Application under Section 73 of the Town and Country Planning Act 1990

Application Ref. DC/26/0135

Resubmission of amended details for an application under Section 73 of the Town and Country Planning Act 1990 seeking to vary Planning Conditions 1, 5, 6, 11, 13 and 19 and remove reference to Planning Conditions 7 and 9 pursuant to the extant Reserved Matters Application Ref. DC/24/0249 at Rascals Farm, Shipley Road, Southwater, West Sussex

Flat block elevations

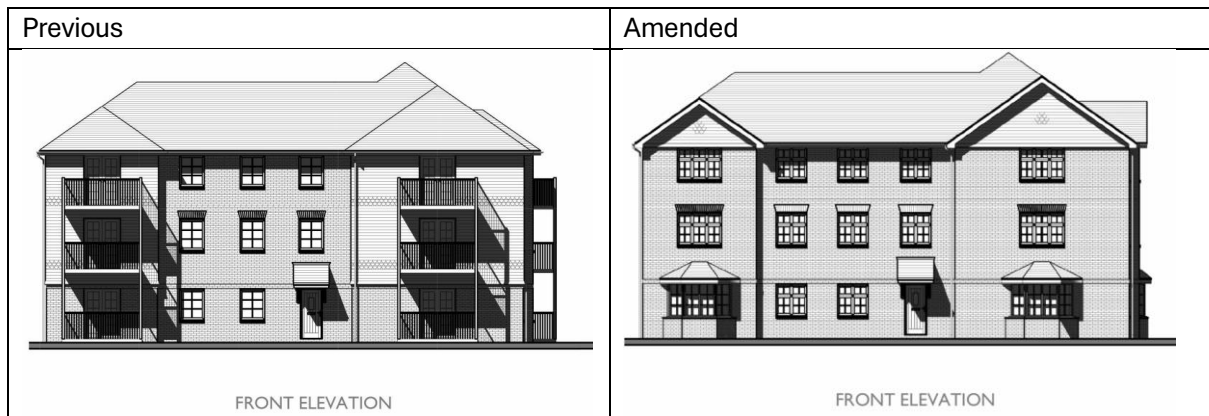
Following discussion with the Case Officer, the flat block elevations have been amended to closer align to that consented within the Reserved Matters scheme. Changes include:

- Removal of balconies
- Addition of Ground Floor bay windows
- Part-Gabbling of roof
- Addition of vertical tile hanging in roof gables with ornamental tiles
- Amendment of window style

Pathways outside of RPA

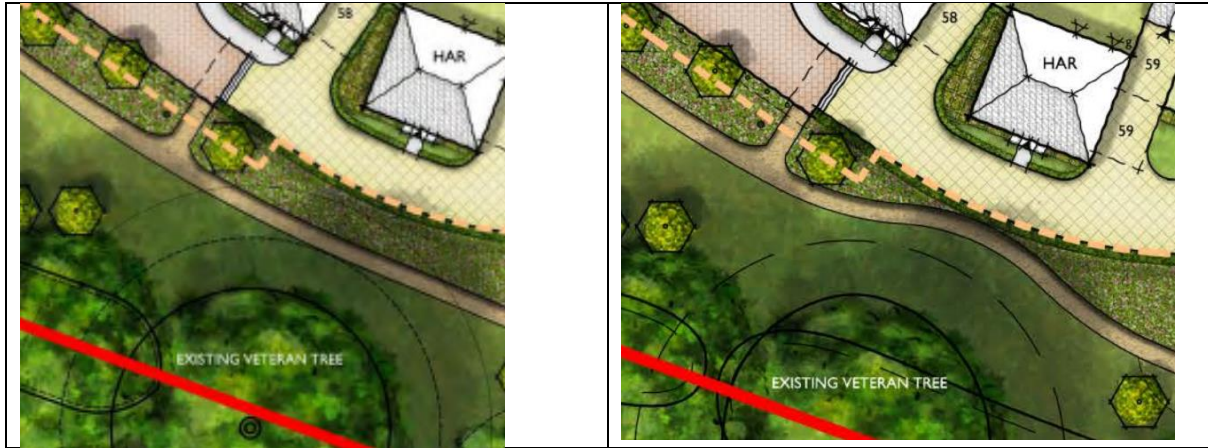
Following consultation from the Horsham DC Tree Officer, the footpath to the south of Plots 58 - 60 has been deviated to closer align to that consented within the Reserved Matters.
